February 14, 2011

Subject: CPV Sentinel Energy Project
Docket No. 07-AFC-3C
Construction Laydown Area Refinement

FIGURE 1

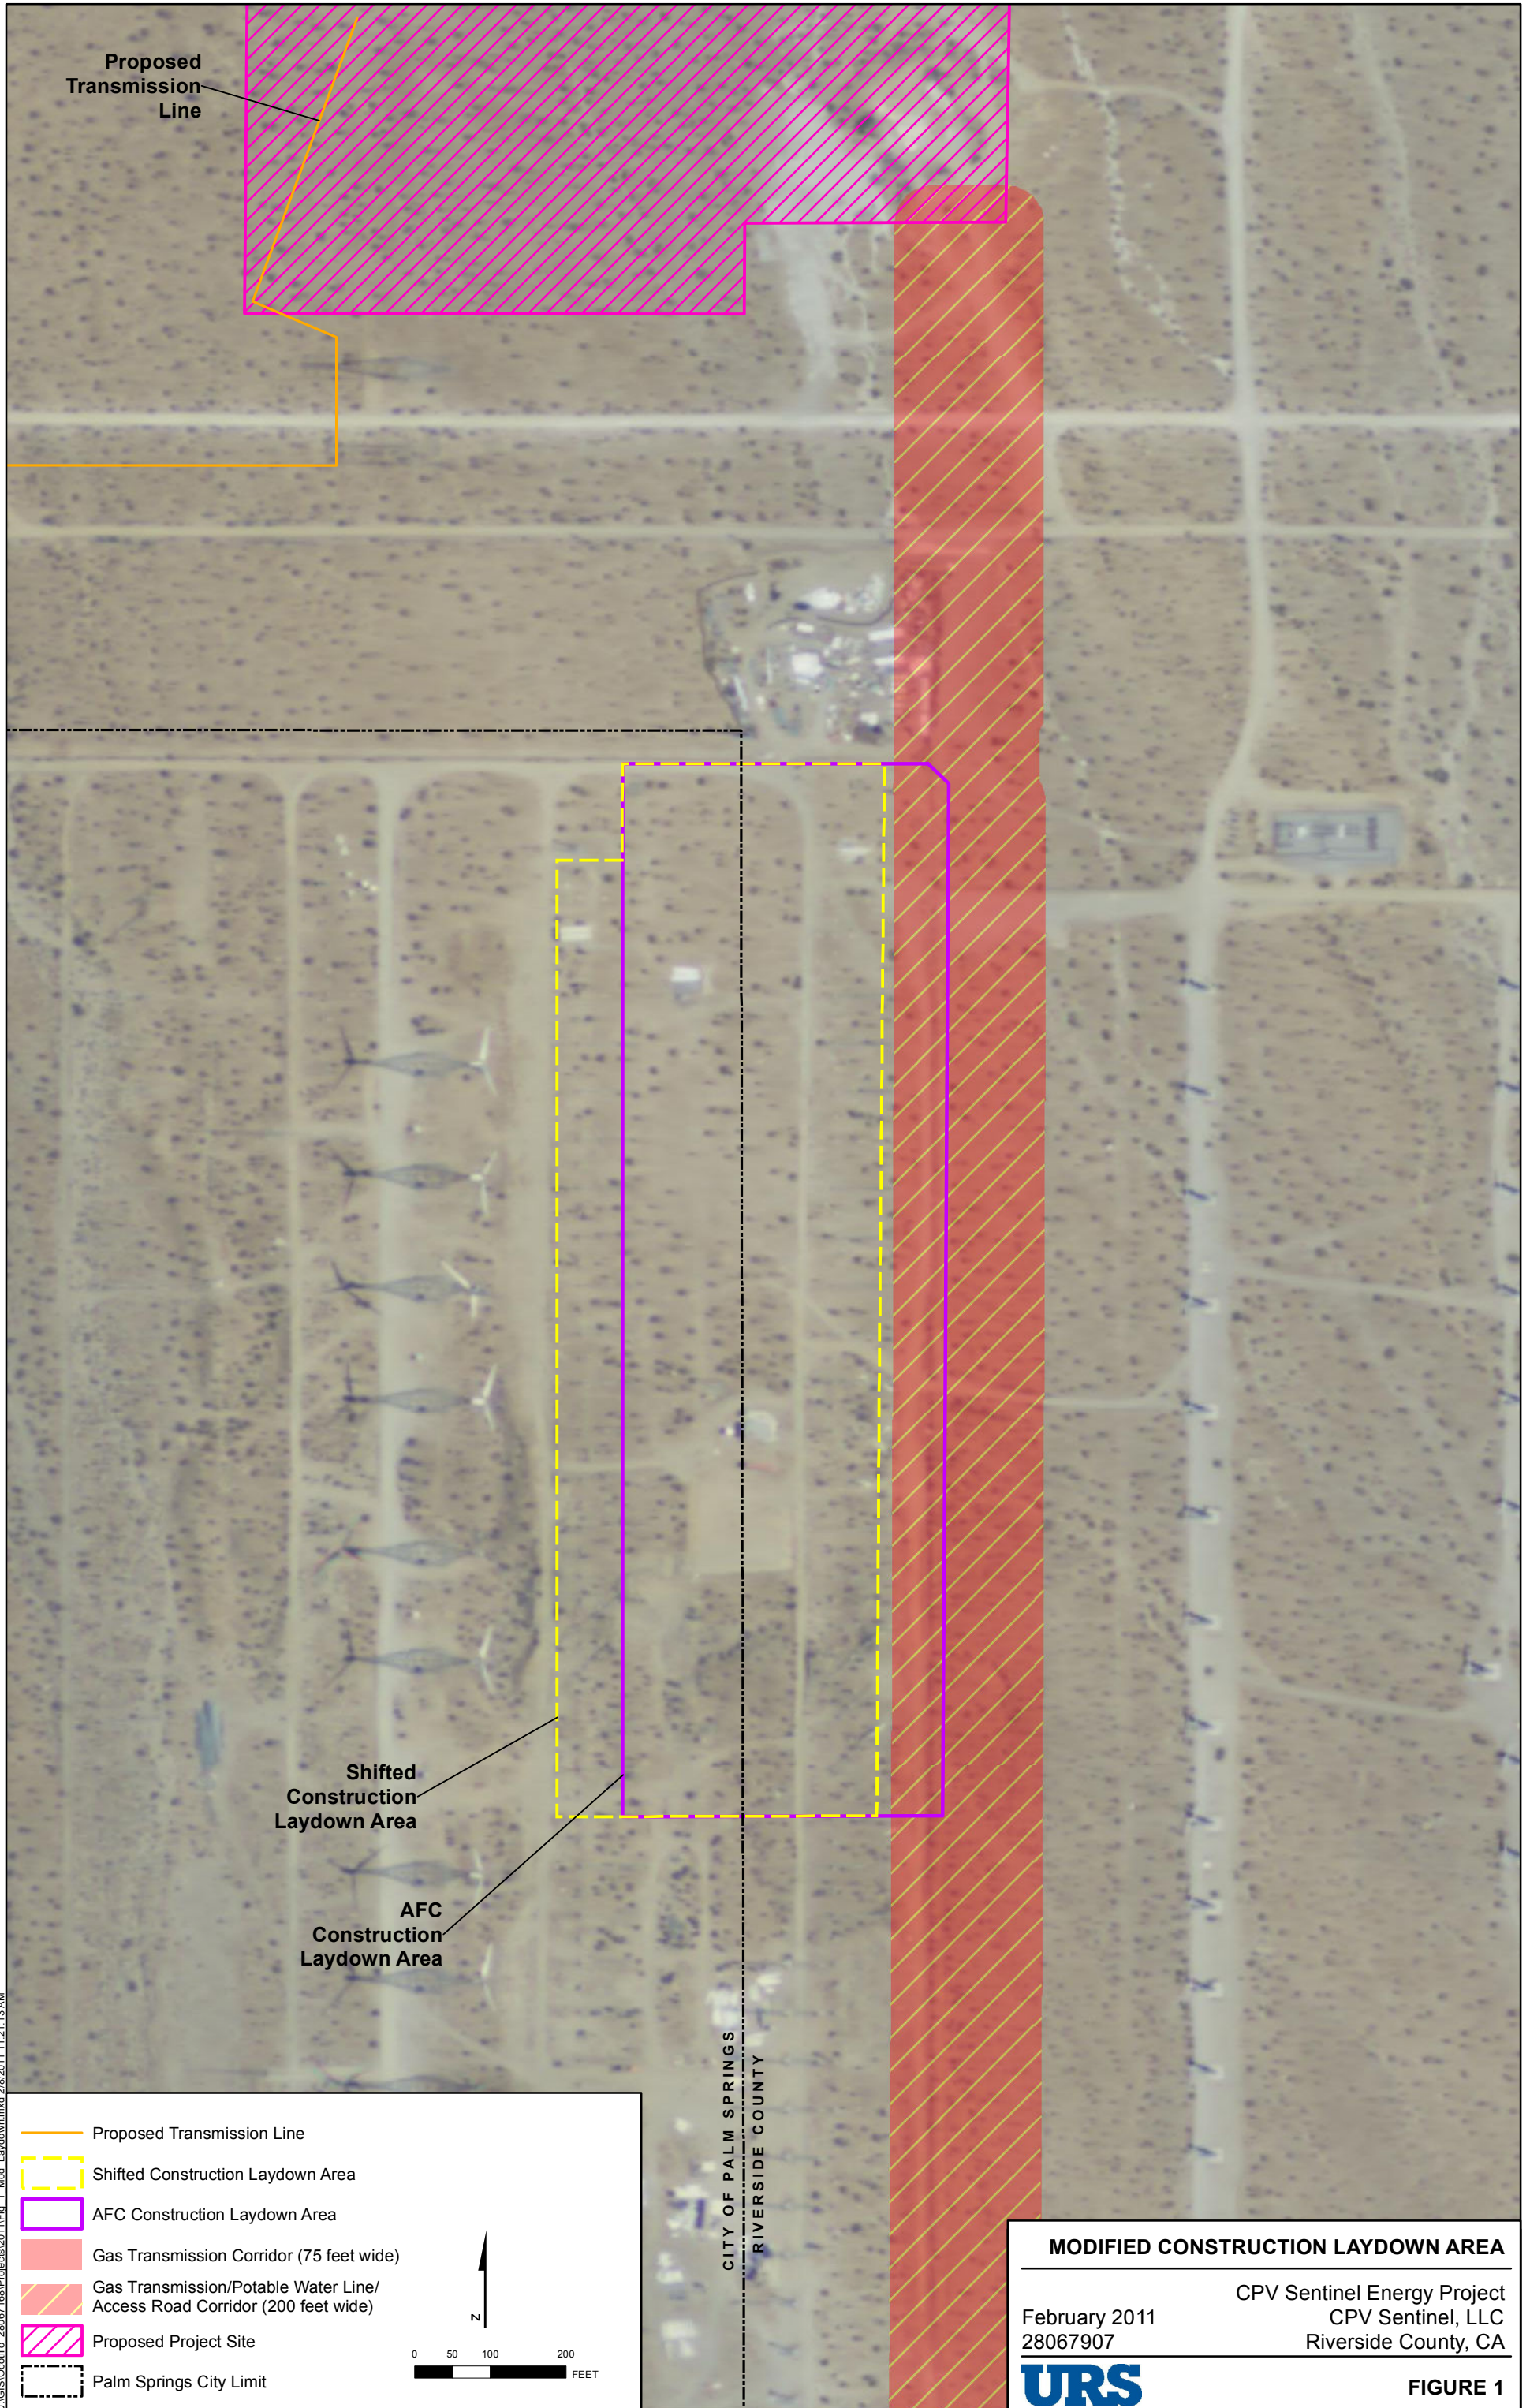
CPV Sentinel, LLC proposes to move the construction laydown area for the CPV Sentinel Energy Project (CPVS) from its currently approved location approximately 50 feet to the west. The new location is necessary to avoid an electric cable now located along the eastern boundary of the area previously proposed in the Application for Certification (AFC).

Please find attached a figure showing the proposed 50-foot shift of the laydown area. As explained further below, this modification does not result in any changes to the environmental consequences of the CPVS. Further, all impacts are expected to remain less than significant with implementation of conditions of certification set forth in the December 2010 Commission Decision.

AFC FIGURE 7.2-1

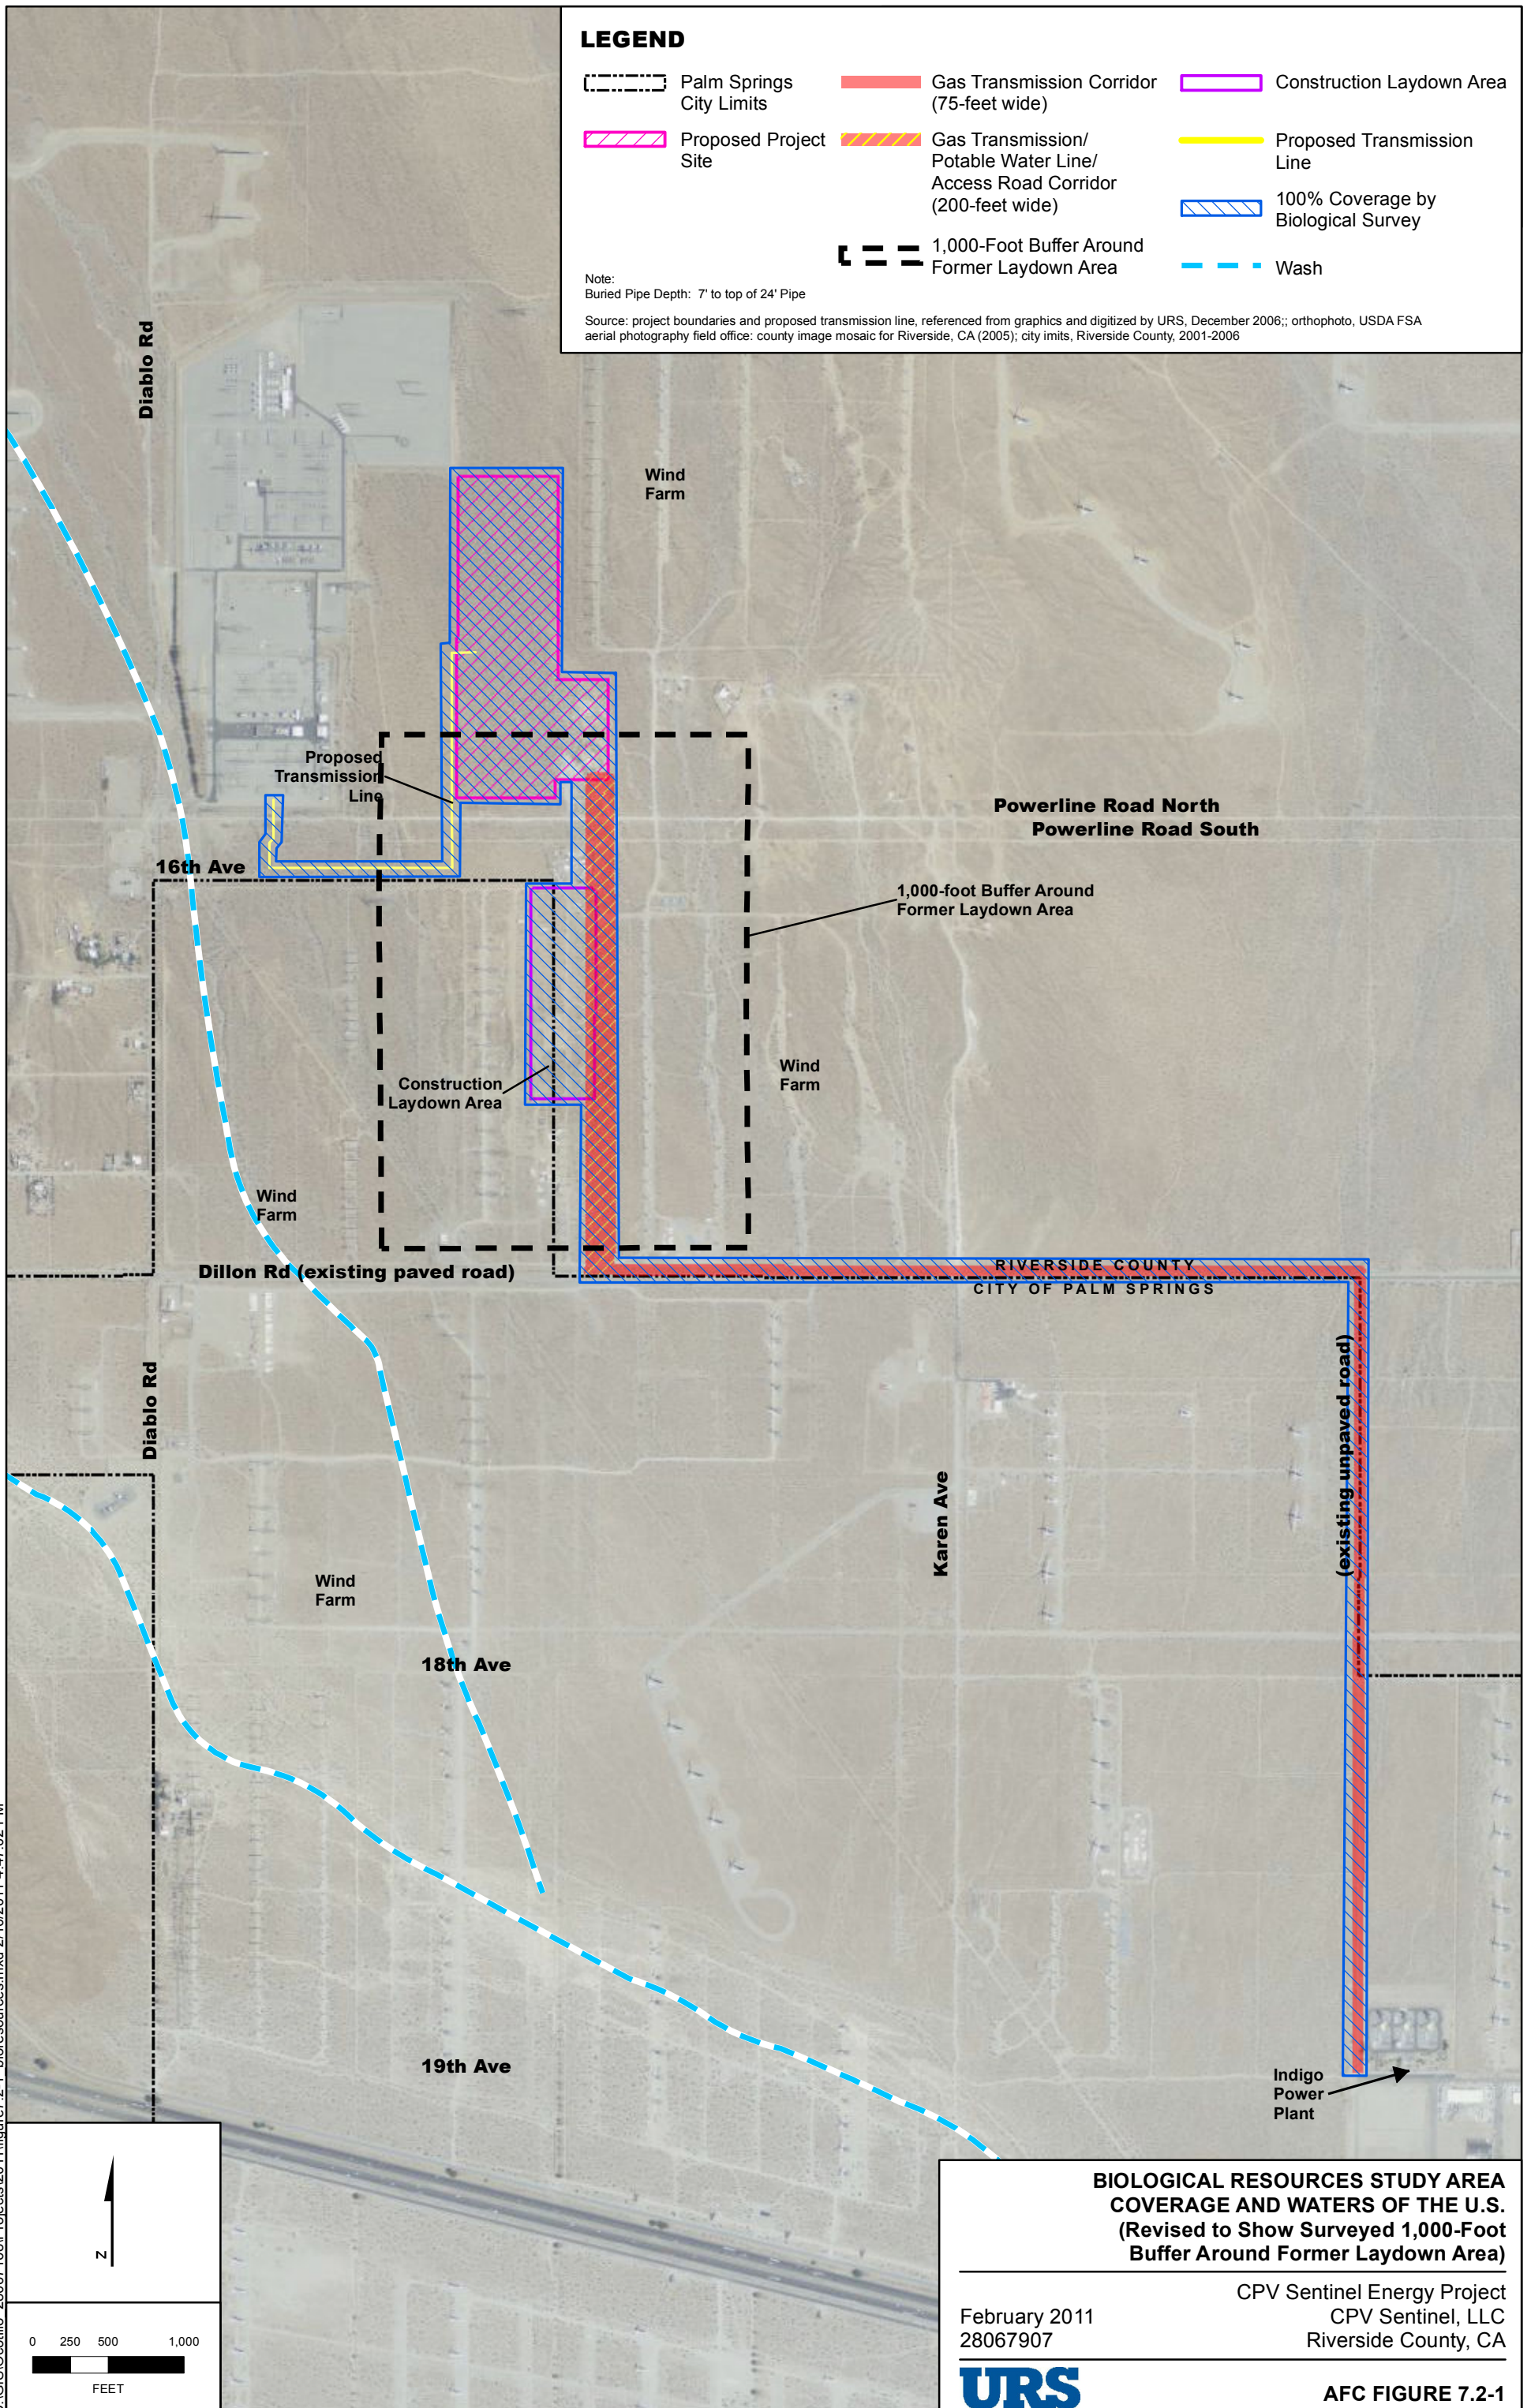
The 50-foot-wide area now affected by the construction laydown area was surveyed for biological resources as part of the 1,000 foot buffer from the laydown area previously proposed in the AFC. Attached is AFC Figure 7.2-1 revised to show specifically this 1,000-foot buffer that was previously surveyed. As part of the general habitat, burrowing owl, rare plant, and desert tortoise surveys, the area was surveyed in 2007, 2008, 2009, and 2011 by URS biologists and/or Xeric Specialties Consulting. No threatened or endangered plant or wildlife species have been observed during biological resource field surveys of the construction laydown area or this 50-foot-wide segment. In addition, pre-construction surveys for rare plants and wildlife species (as required by conditions of certification in the Commission Decision) would include surveying this new area. The slight modification to the laydown area would not change the analysis of potential impacts to biological resources as previously described in the AFC Section 7.2, and set forth in the Commission Decision. Impacts to biological resources are expected to be less than significant with implementation of conditions of certification.
